**105th Ave N and Northwood Area Improvements
Maple Grove, MN
Lumen Facilities
Reviewed by RJ Allison on 02/07/2022**

Below are the following Lumen conflicts as part of the 105th Ave N and Northwood Area Improvements Project in Maple Grove, MN.

NORTHWOOD CHURCH/WESTON COMMONS STREET AND UTILITY IMPROVEMENTS

SURVEY	TNA
DRAWN	JLT/ASB
DESIGNED	JLT/ASB
CHECKED	TMM
APPROVED	TJM
PROJ. NO.	193805396
SHEET NUMBER	C4.02

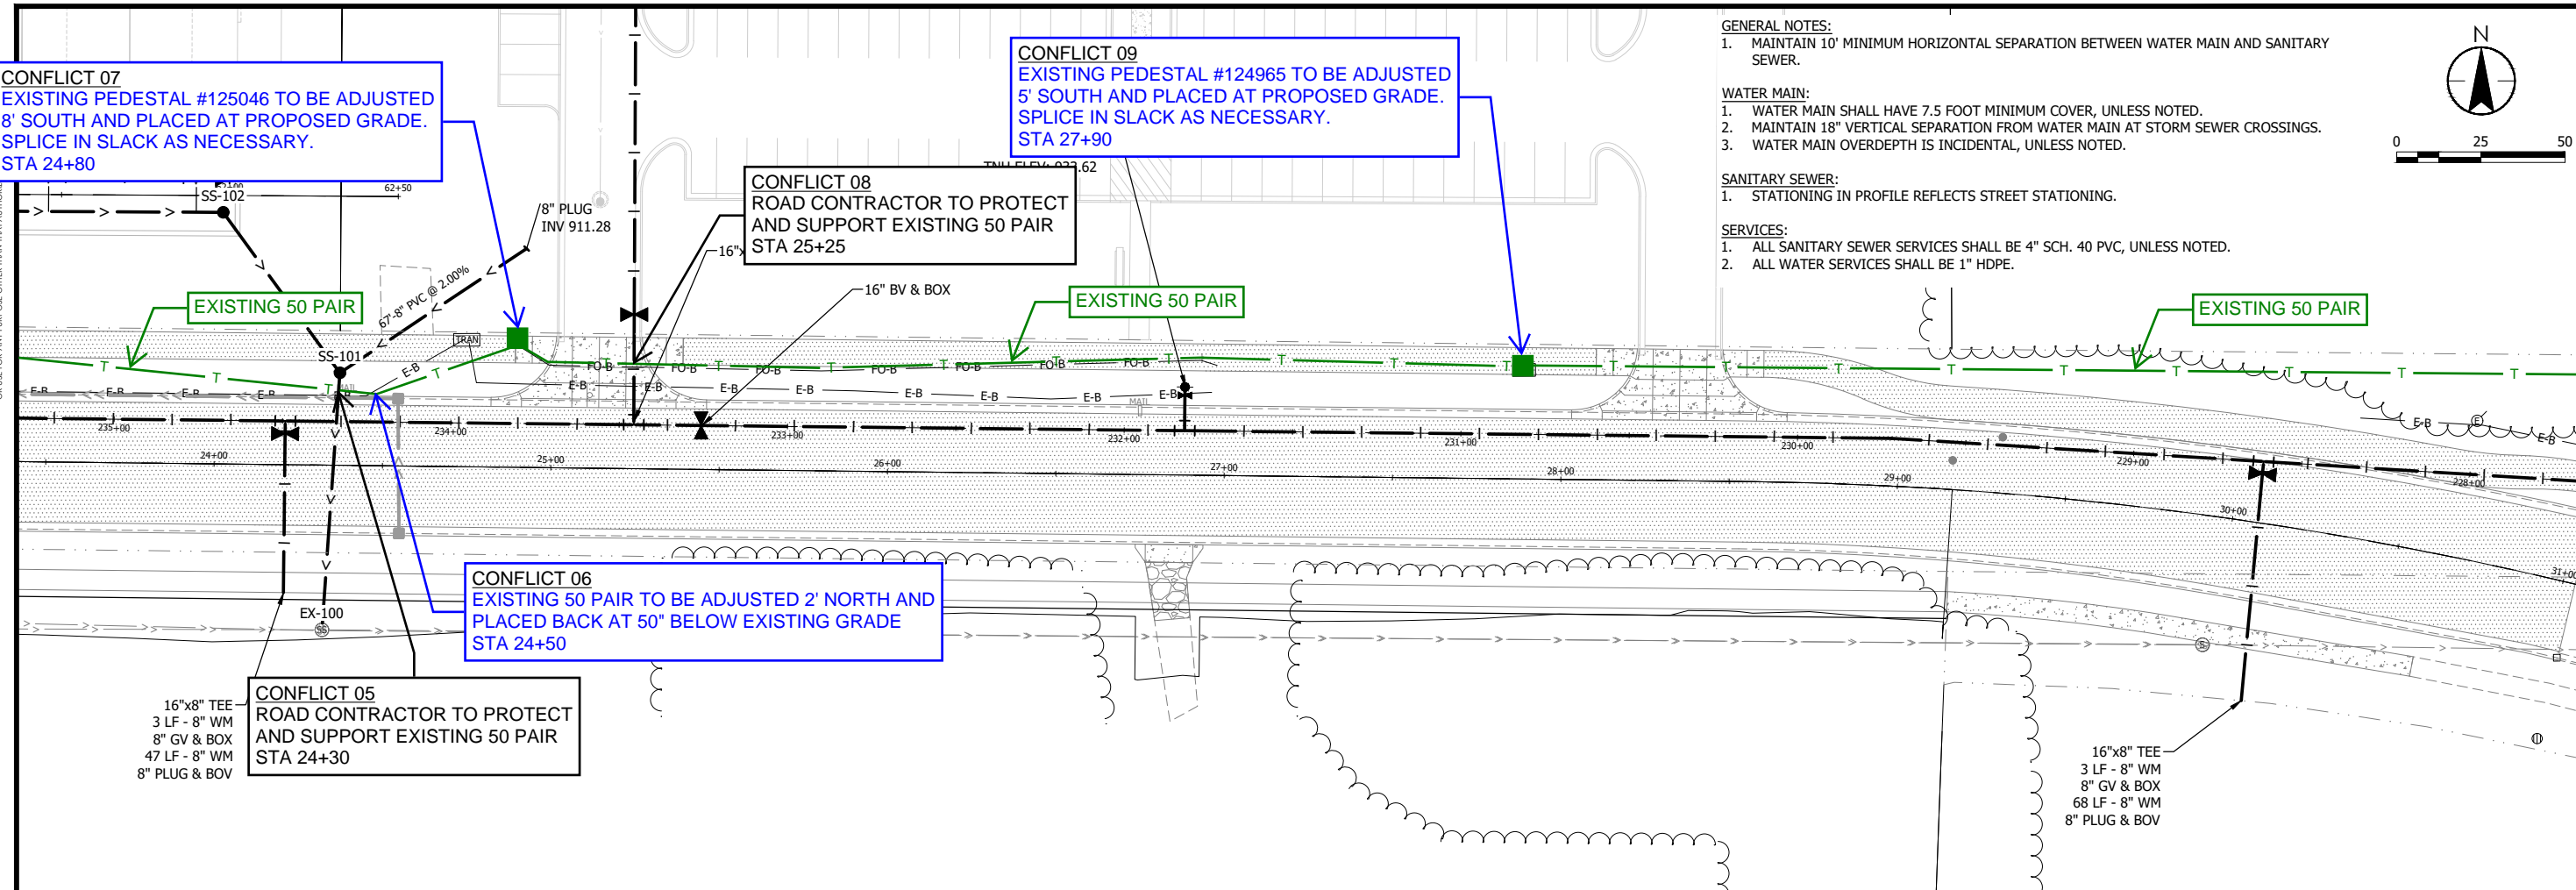
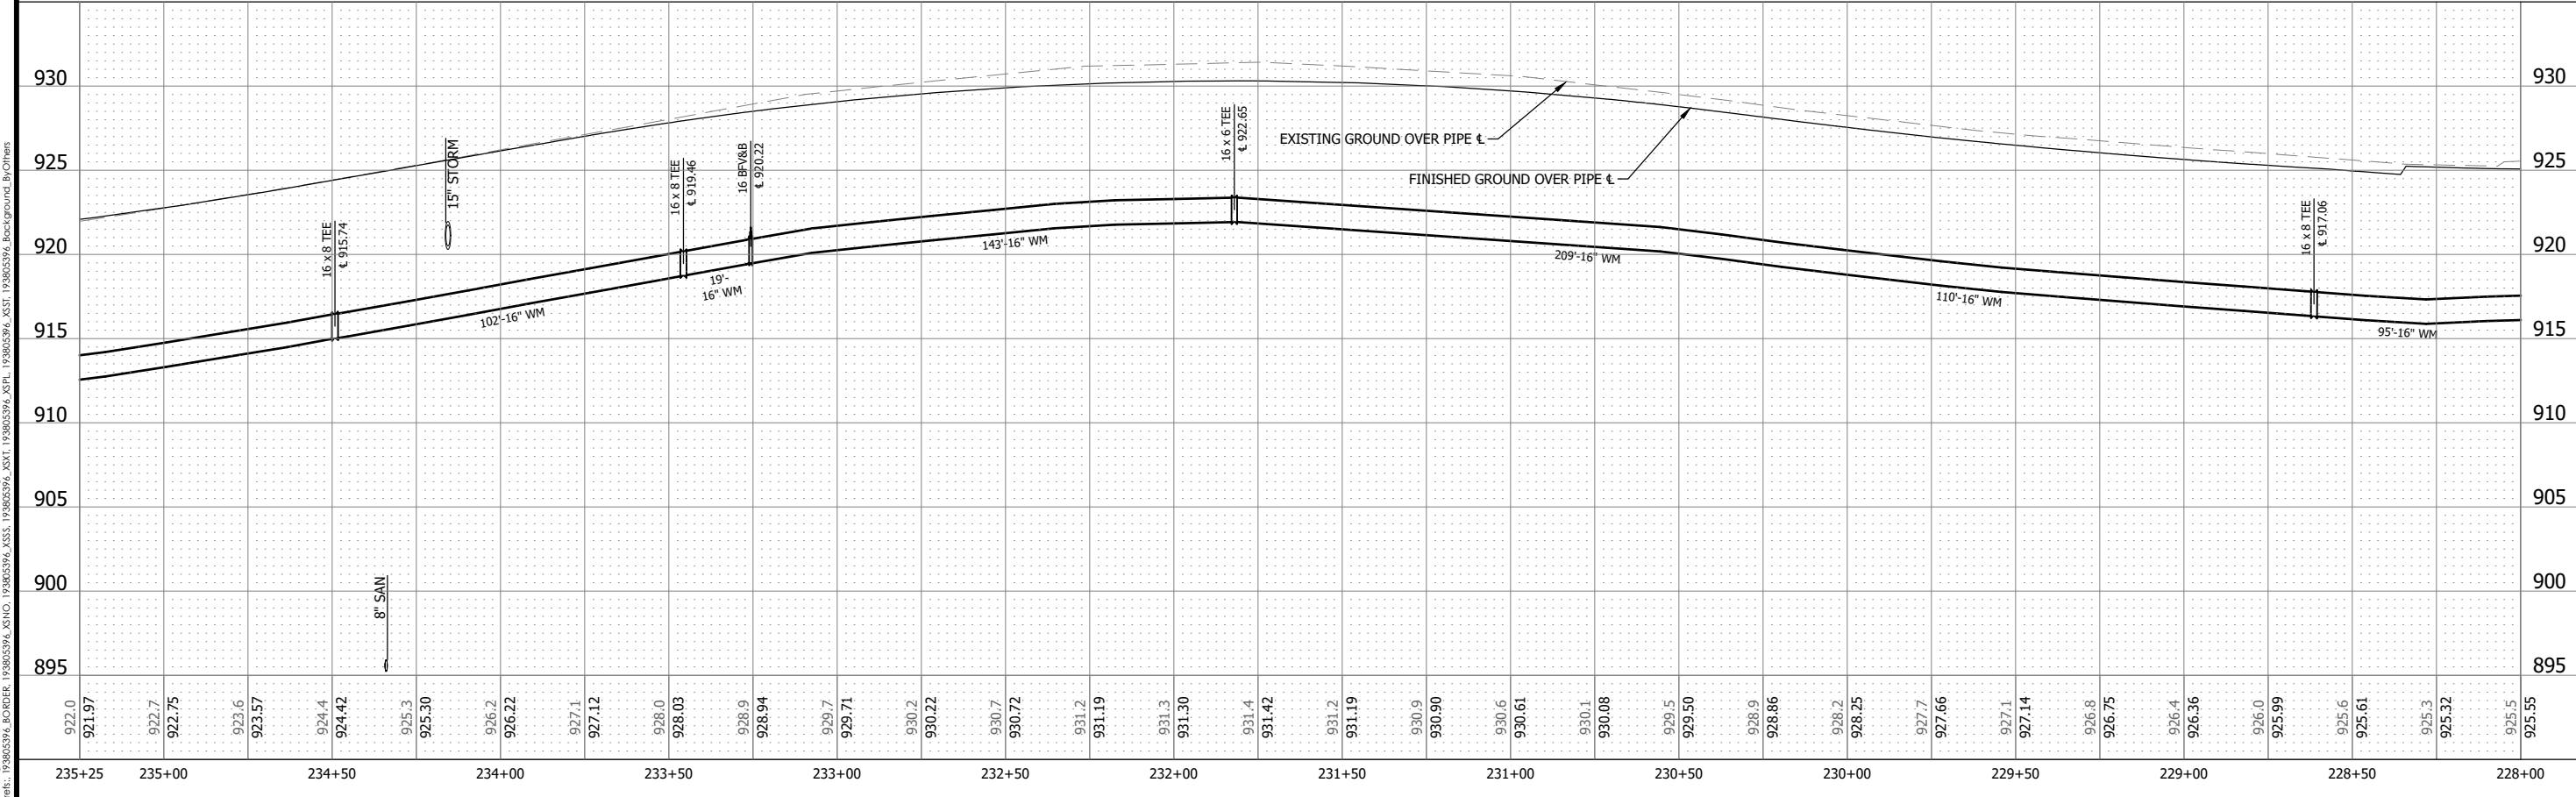
05. 105th Ave N, STA 24+30 (LT), Sheet C4.02
Conflict: Existing 50 pair crossing above proposed storm sewer.
Solution: Road contractor to protect and support cable.

06. 105th Ave N, STA 24+50 (LT), Sheet C4.02
Conflict: Existing 50 pair in conflict with proposed storm sewer.
Solution: Lumen to adjust cable 2' North and placed back at 50" below existing grade.

07. 105th Ave N, STA 24+80 (LT), Sheet C4.02
Conflict: Existing pedestal in conflict with proposed trail.
Solution: Lumen to adjust pedestal 8' South and placed at proposed grade. Splice in slack as necessary.

08. 105th Ave N, STA 25+25 (LT), Sheet C4.02
Conflict: Existing 50 pair crossing above proposed watermain.
Solution: Road contractor to protect and support cable.

09. 105th Ave N, STA 27+90 (LT), Sheet C4.02

Conflict: Existing pedestal in conflict with proposed trail.

Solution: Lumen to adjust pedestal 8' South and placed at proposed grade. Splice in slack as necessary.

SURVEY	TNA
DRAWN	JLT/ASB
DESIGNED	JLT/ASB
CHECKED	TMB
APPROVED	TJM
PROJ. NO.	193805396
SHEET NUMBER	C4.09

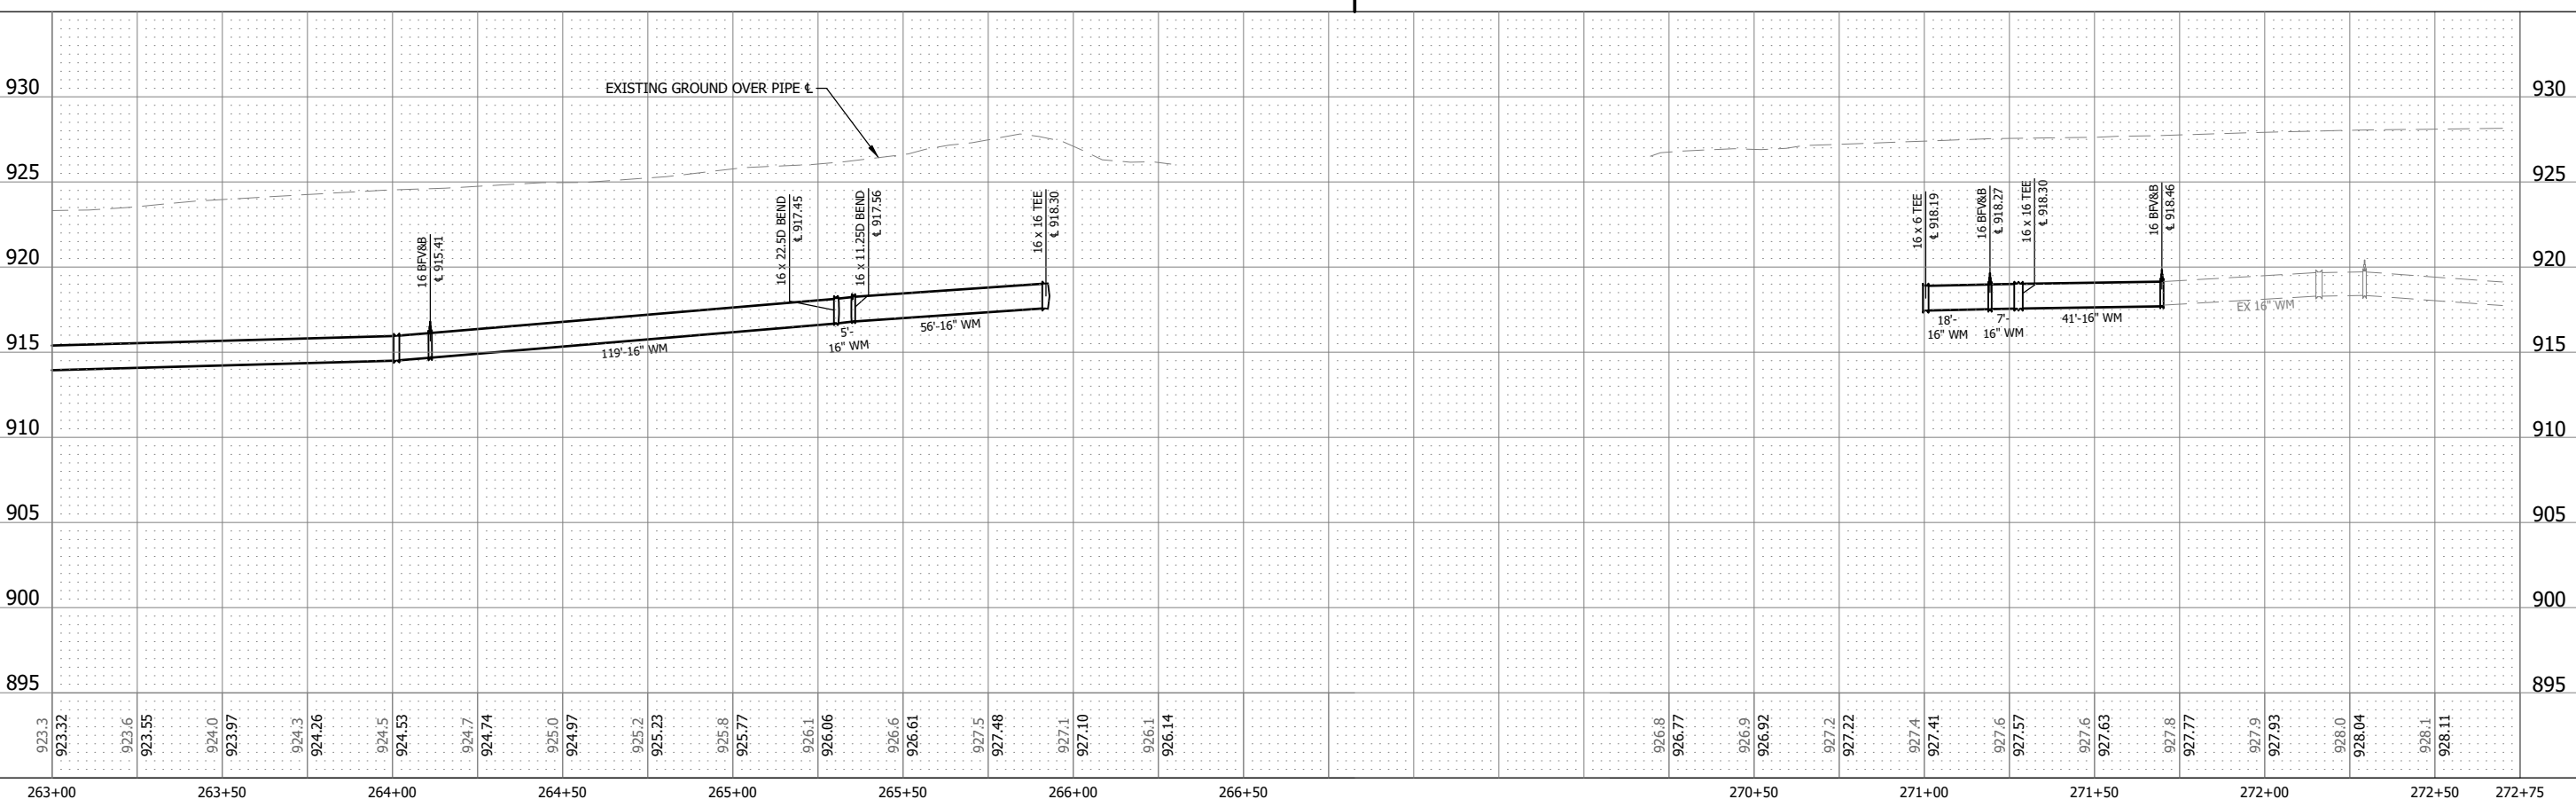
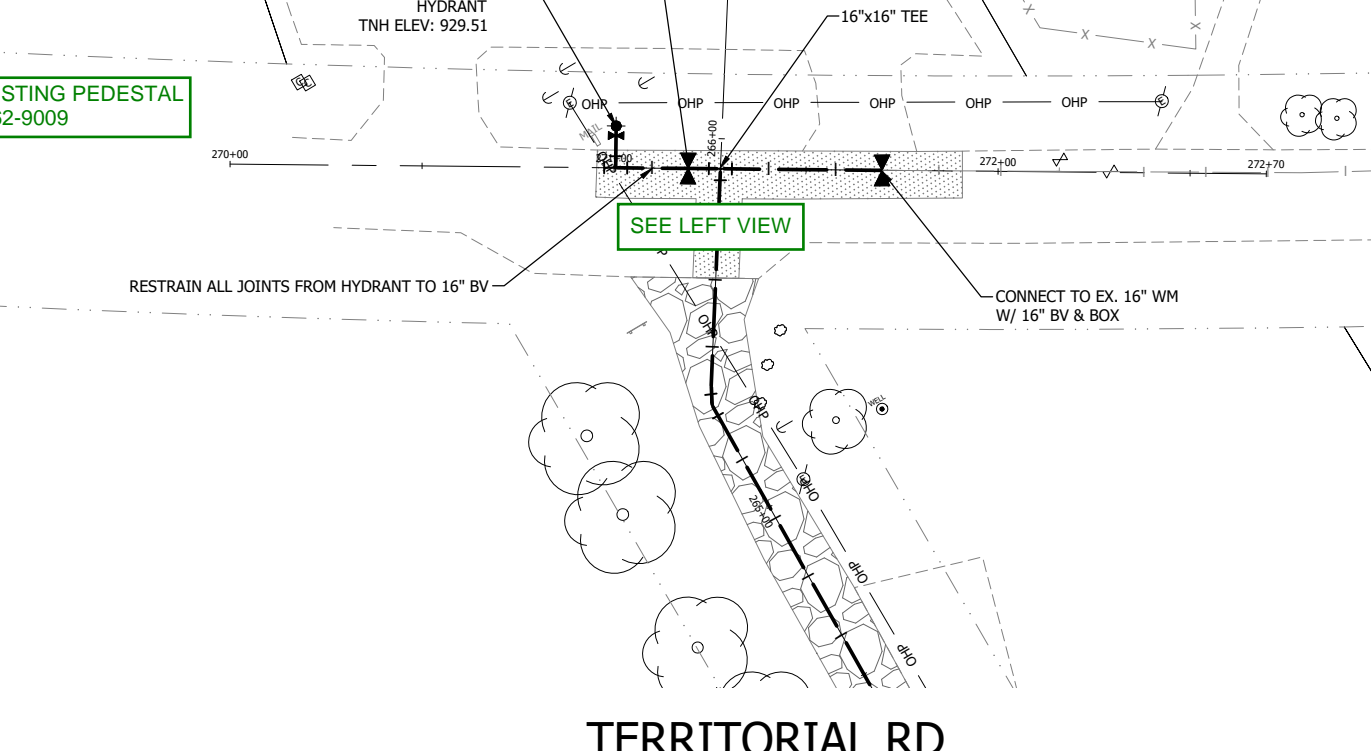
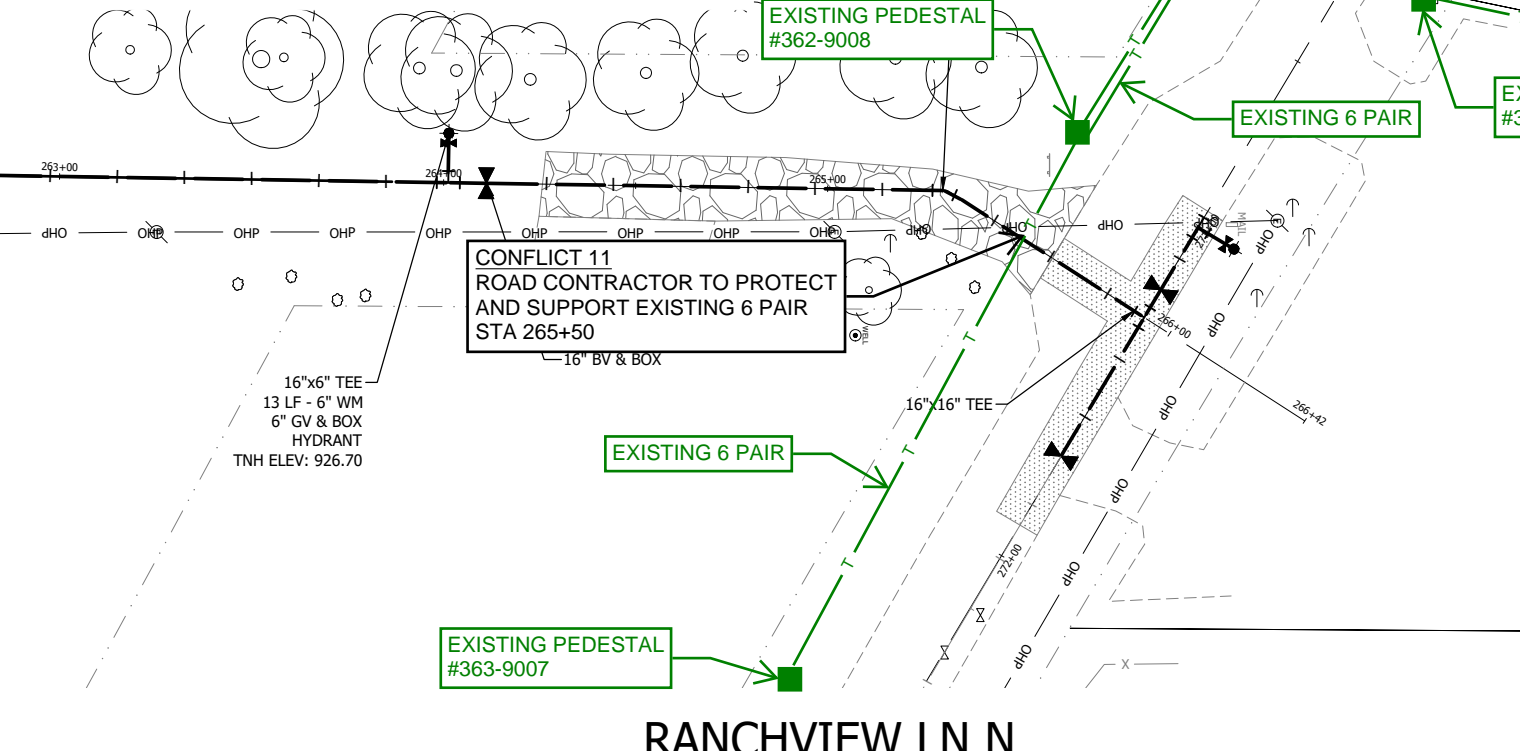
11. RR Watermain Crossing, STA 265+50 (CL), Sheet C4.09

Conflict: Existing 6 pair crossing above proposed watermain.

Solution: Road contractor to protect and support cable.
